service bulletin

No. 97-1

Torquing Intake Manifold on Gen+ Engines

72878

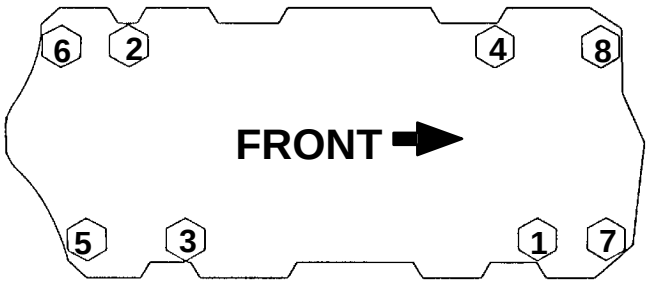
The intake manifold on all Gen+ engines use a special torquing procedure. The following procedure must be used whenever an intake manifold is installed. Failure to follow this procedure could cause the intake manifold gasket to leak coolant into the oil or on top of manifold.

Torque intake manifold bolts in 3 steps and in sequence shown below.

1. 27 lb. in. (3 N.m).
2. 106 lb. in. (12 N.m).
3. 133 lb. in. (15 N.m).
